DEVELOPMENT APPLICATION ASSESSMENT

REPORT TO JOINT REGIONAL PLANNING PANEL

253 - 255 Oxford Street, Bondi Junction (DA-539/2013)

Figure 4: 9am shadow comparison

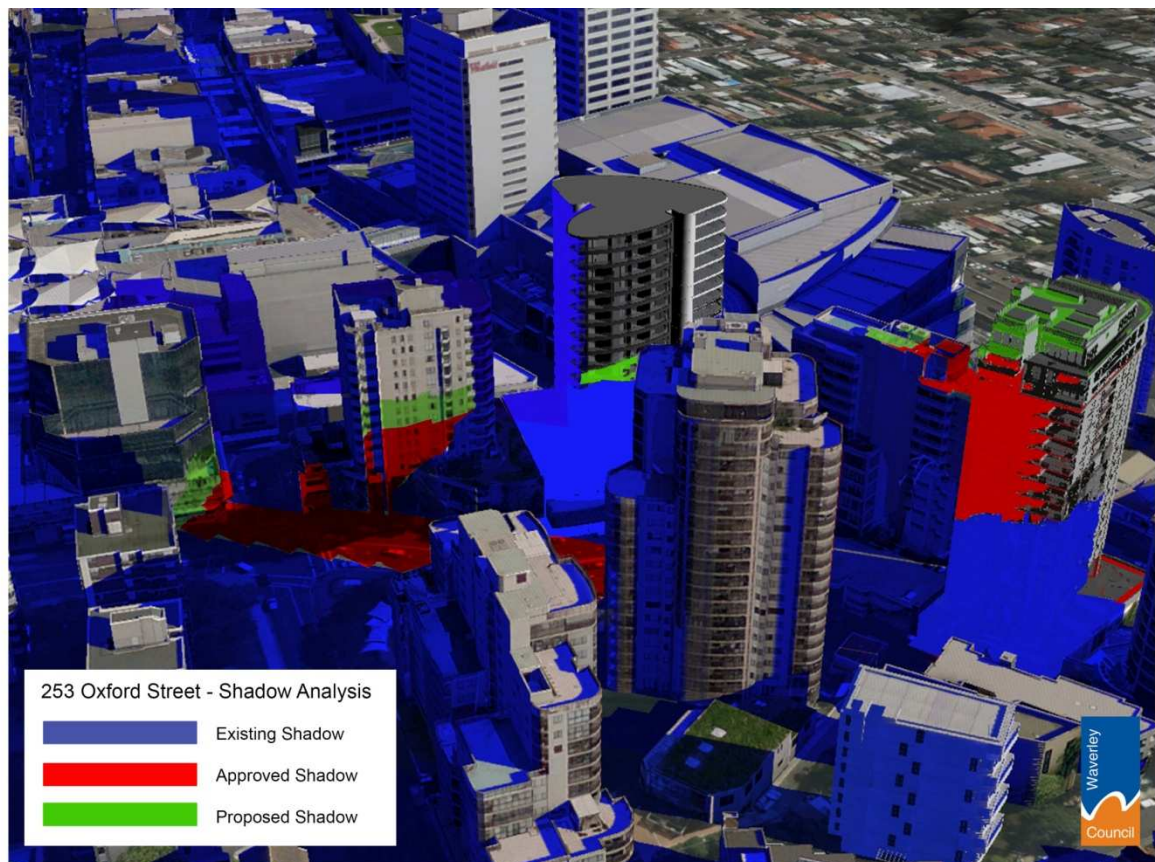
Figures 4, 5 and 6 below demonstrate the shadow of the approved building **in red** (with compliant height and FSR approved under DA-386/2012) and additional shadow cast from the proposed building with 2 additional levels which breach the 60m height limit **in green**. The existing shadow of surrounding buildings is shown **in blue**.

As shown in the diagram above, the proposal will affect the sunlight of additional units in nearby residential flat buildings, which would not be effected by the approved (and compliant) building. The building was approved under DA-386/2012 with a compliant building height and floor space. That sunlight would be retained under compliant building which was approved by the Joint Regional Planning Panel.

The redistribution 15% bonus floor space to within the building envelope controls (ie. within the 60m height) would remove the majority of impacts to those residential flat buildings that have been identified in the figures 4,5 and 6 above.
